III. Revisions, Clarifications, and Corrections to the Draft EIR

This section of the Final EIR provides changes to the Draft EIR that have been made to revise, clarify, or correct the environmental impact analysis for District NoHo (the Project). Such changes are a result of public and agency comments received in response to the Draft EIR and/or additional information that has become available since publication of the Draft EIR. The changes described in this section do not result in the Project creating any new or increased significant environmental impacts.

A. Corrections and Additions to Draft EIR Sections and Appendices

Revised Figure II-3
 Conceptual Site Plan-Ground Level and Block Heights

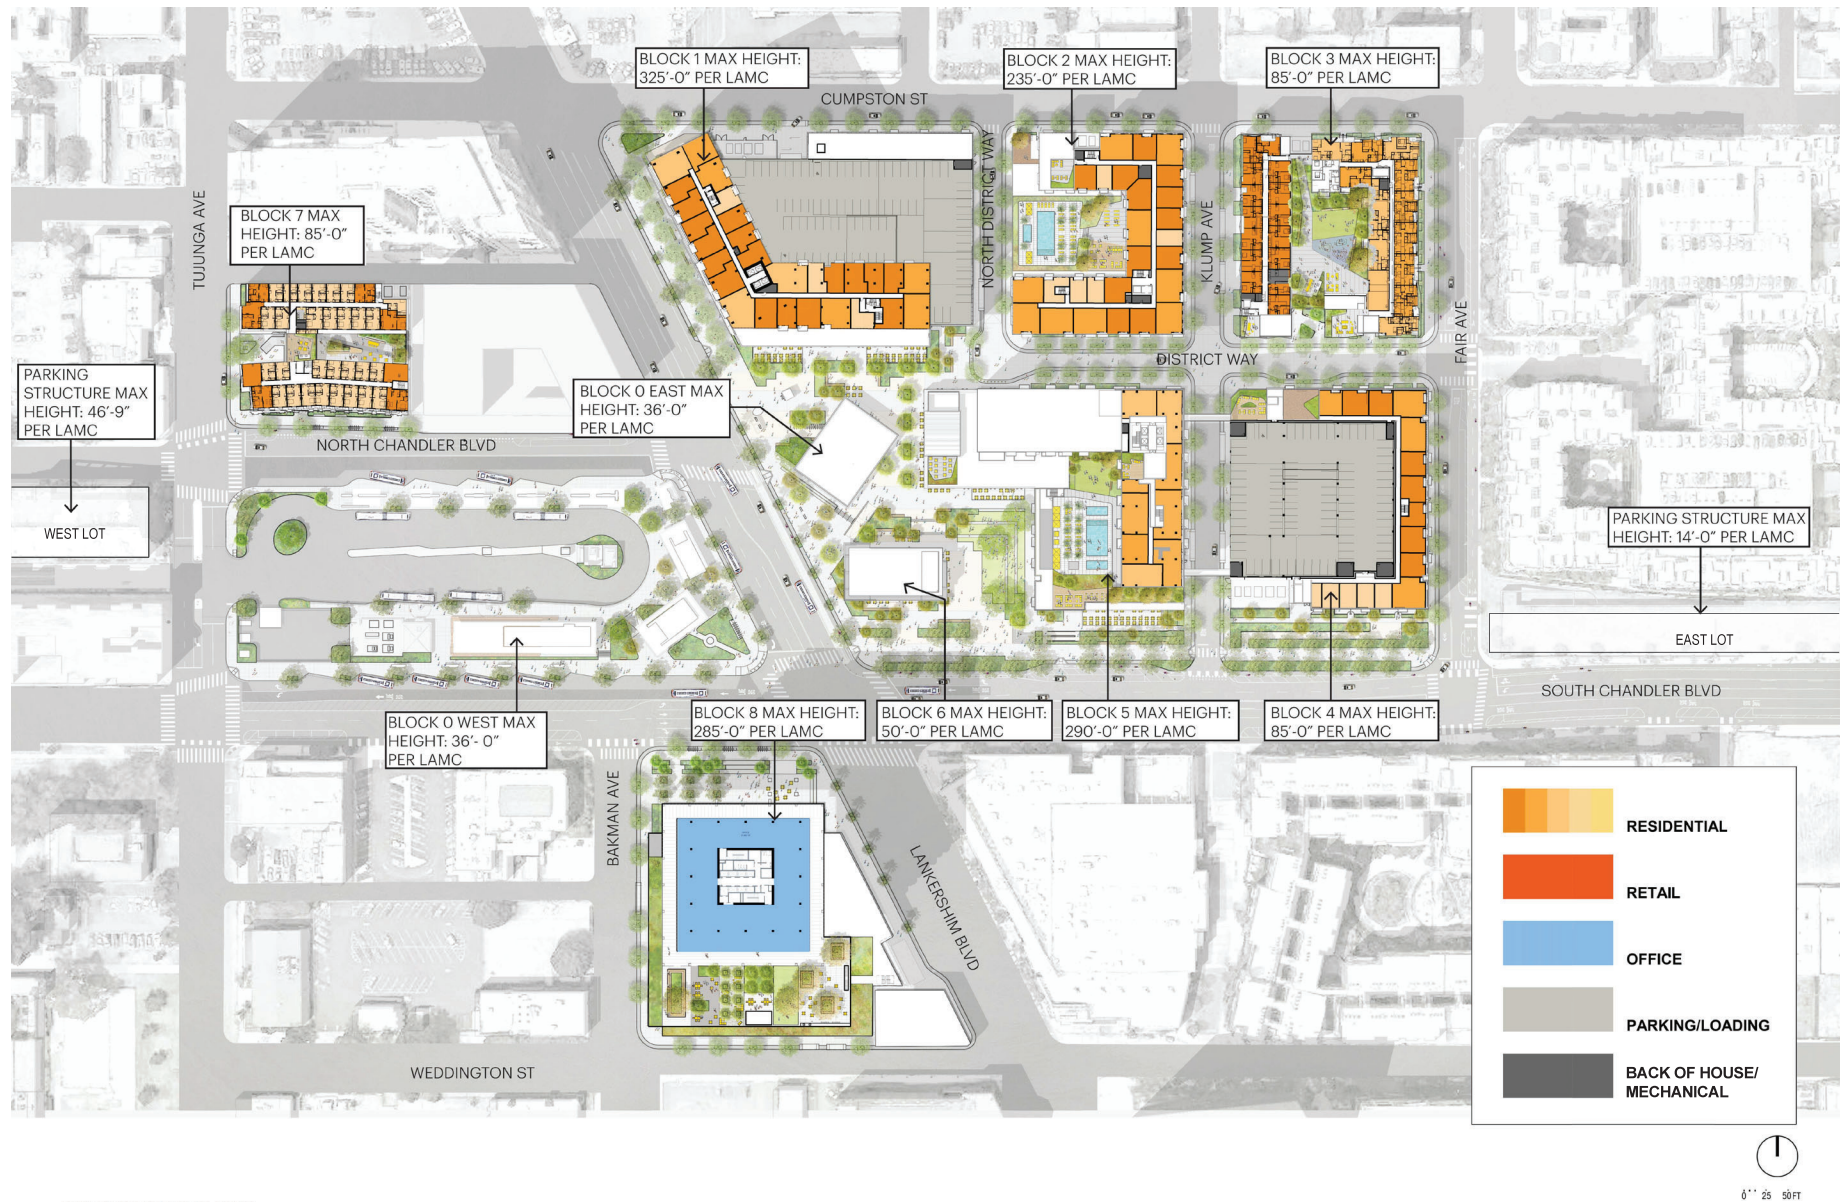
As shown in Revised Figure II-3 on page II-14, III-16 of the Final EIR, the East Site is located north of Chandler Boulevard, south of Cumpston Street, east of Lankershim Boulevard, and west of Fair Avenue, and is currently developed with a Metro B (Red) Line east portal, bus plaza, and surface parking. The East Site includes approximately 10.67 acres (464,992 square feet before dedications and mergers) and would be subdivided into six development blocks referred to as Block 0 East, Block 1, Block 2, Block 3, Block 4, and Block 5/6 as part of the tract map process.¹³ As part of the Project, the blocks would be transected by a new publicly accessible ~~private street grid of two internal private drives~~. ~~The grid would include two north-south streets which would align with existing streets, Klump Avenue and Elmer Avenue, and extend through the East Site. A~~ The first new drive would be a north-south drive, which would align with Klump Avenue. The second new street, drive, District Way, would run generally east-west through the Project Site connecting with Klump Avenue and Elmer Avenue, as well as Fair Avenue to the east, Fair Avenue to the east, and curving north to connect with Cumpston Street. These internal publicly accessible private streets

Section II, Project Description, page II-14, replace Figure II-3 with Revised Figure II-3 on page III-16 of this Final EIR.

Section II, Project Description, page II-15, replace Figure II-4 with Revised Figure II-4 on page III-17 of this Final EIR.

Revised Figure II-8
Blocks 2 and 4 Alternative Use

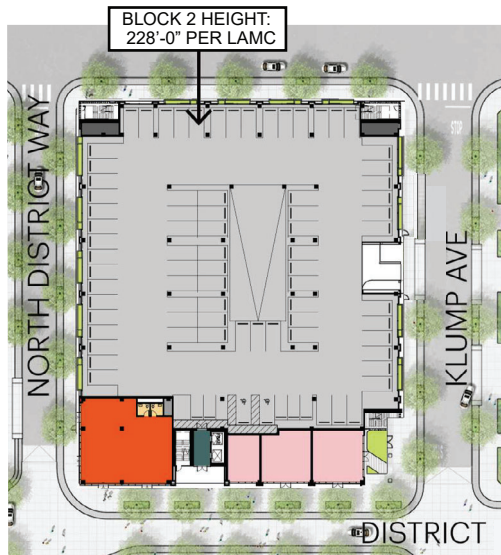
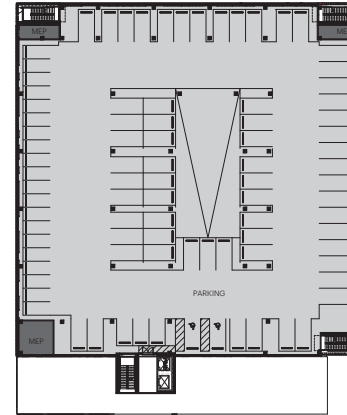
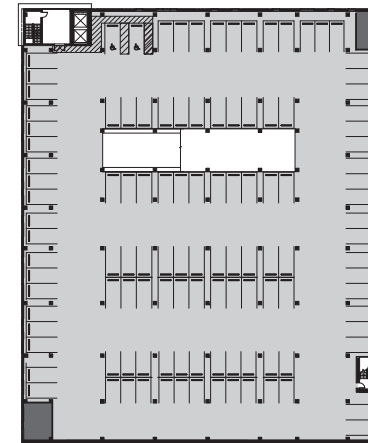
Alternately, one above-grade standalone parking facility could be provided on either Block 2 or Block 4. Should a parking structure be developed on Block 2, it would be in lieu of ~~309-166~~ residential units, but still would include ground floor retail uses. Moreover, the parking structure would be skinned to ensure that parking areas were not visible and compatible with the architectural design of the Project. This alternate use is shown in Revised Figure II-8 on page II-22 III-21 of the Final EIR.

Section II, Project Description, page II-22, replace Figure II-8 with Revised Figure II-8 on page III-21 of this Final EIR.

Revised Figure II-9
Public Plazas

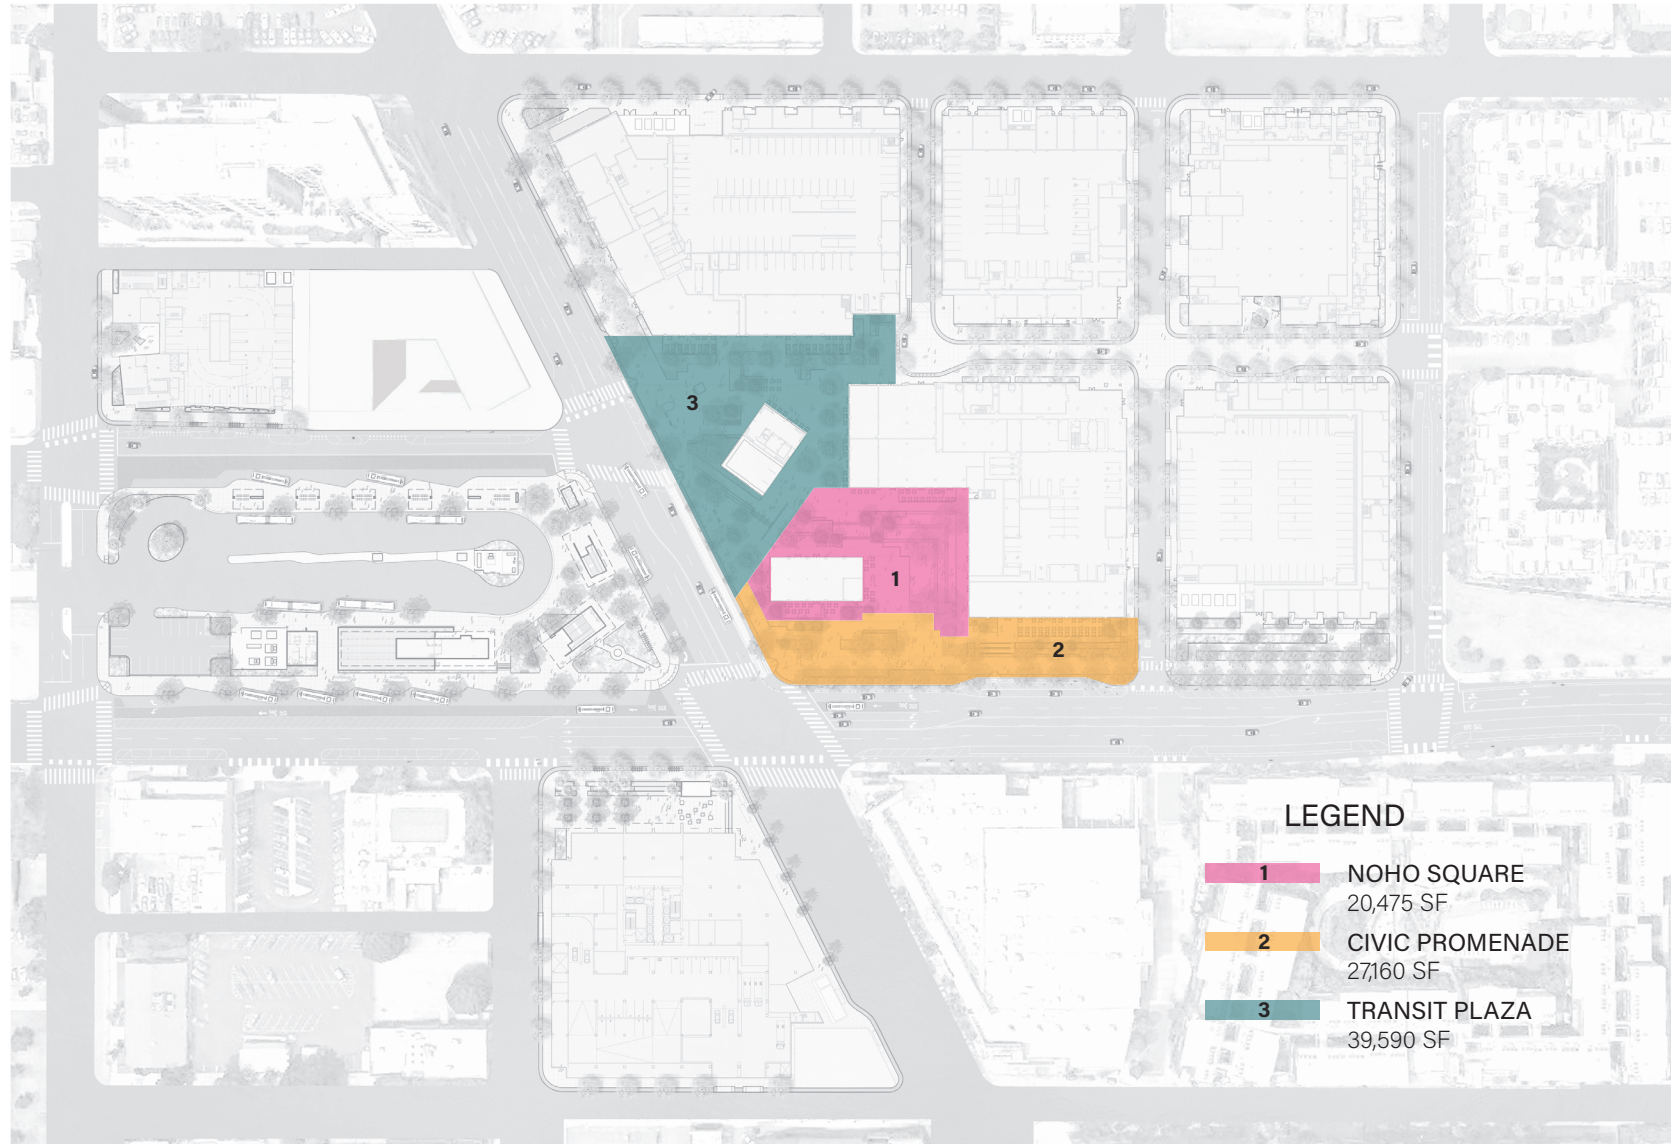
As shown in Revised Figure II-9 on page ~~II-27~~ III-26 of the Final EIR, the center of the Project Site would feature the publicly accessible Promenade, Transit Square, and NoHo Square.

Section II, Project Description, page II-27, replace Figure II-9 with Revised Figure II-9 on page III-26 of this Final EIR.

Revised Figure II-10
Landscaping Overview

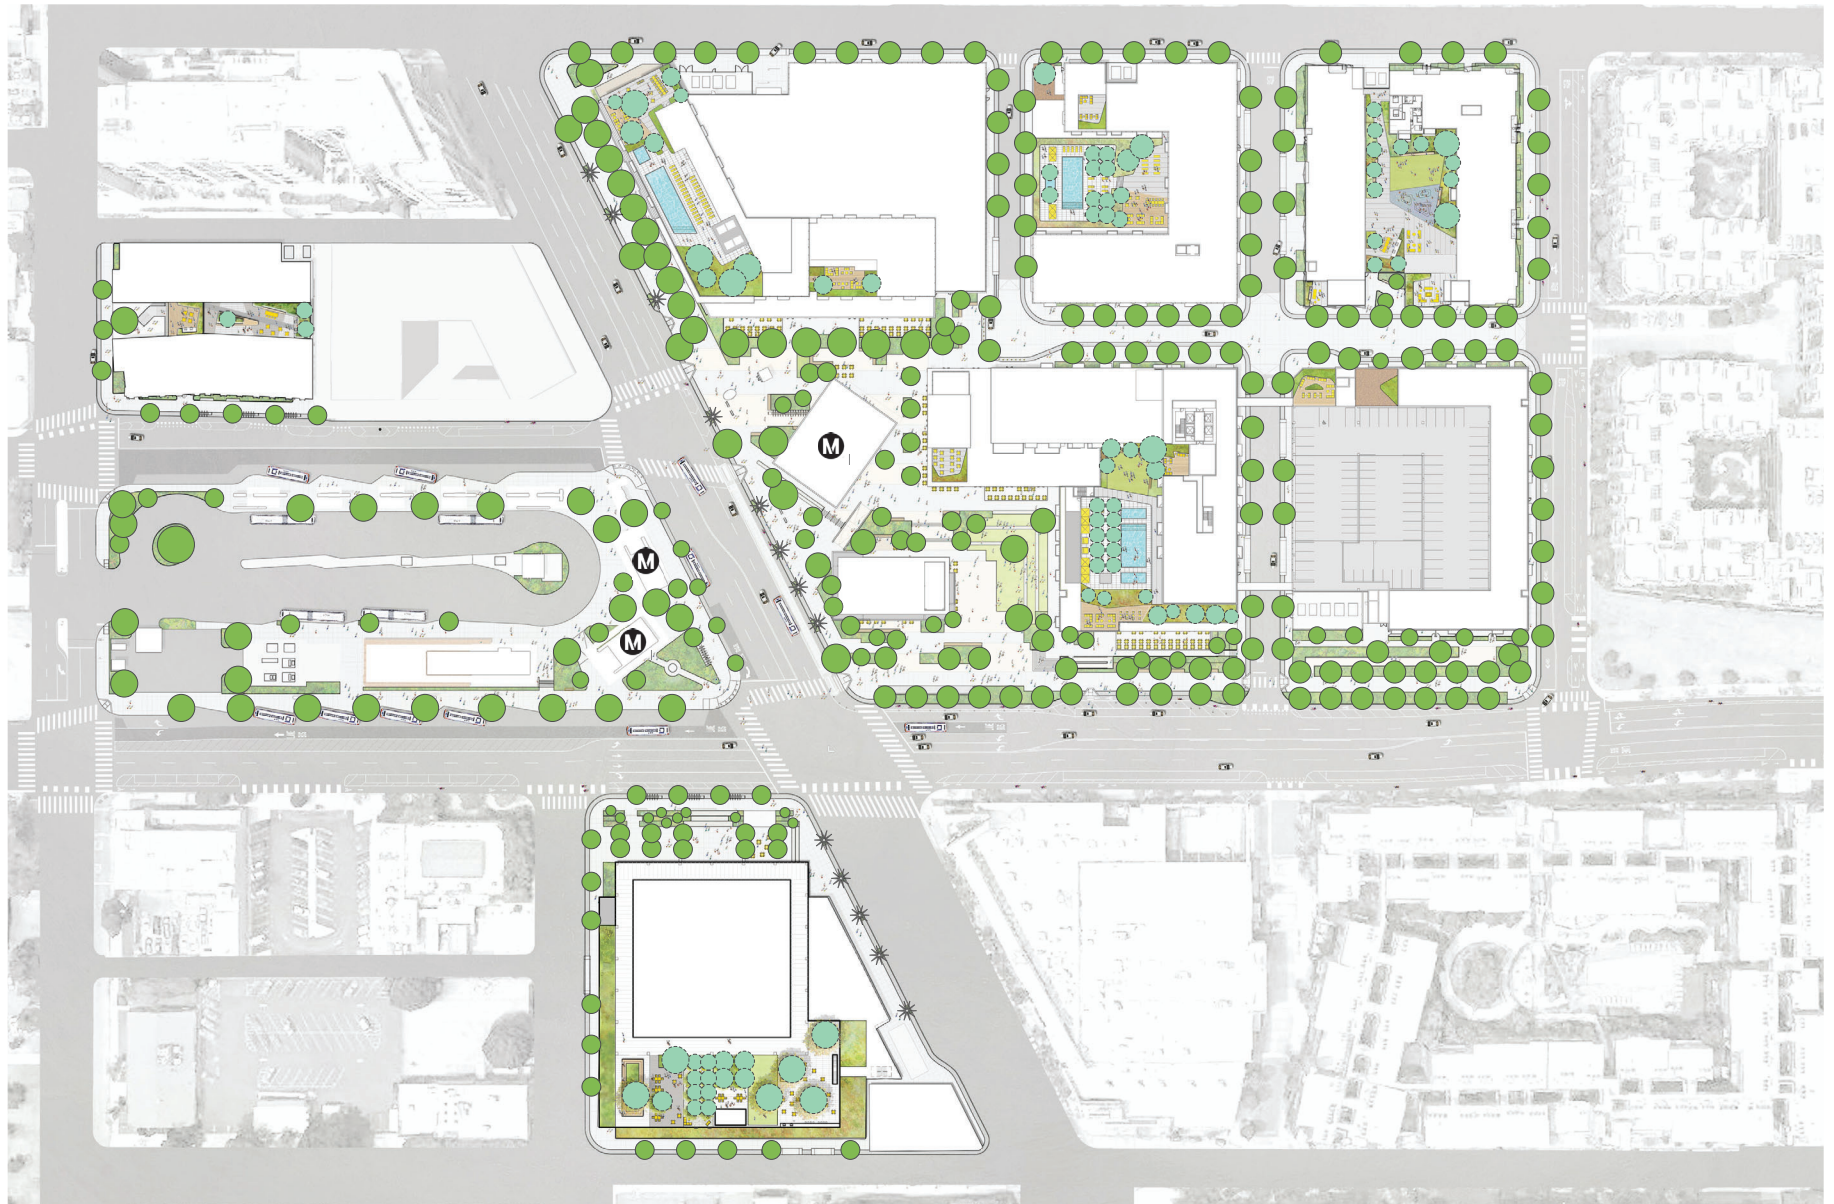
An overview of the Project's landscaping is provided in Revised Figure II-10 on page ~~II-28~~ III-29 of the Final EIR.

Section II, Project Description, page II-29, replace Figure II-10 with Revised Figure II-10 on page III-29 of this Final EIR.
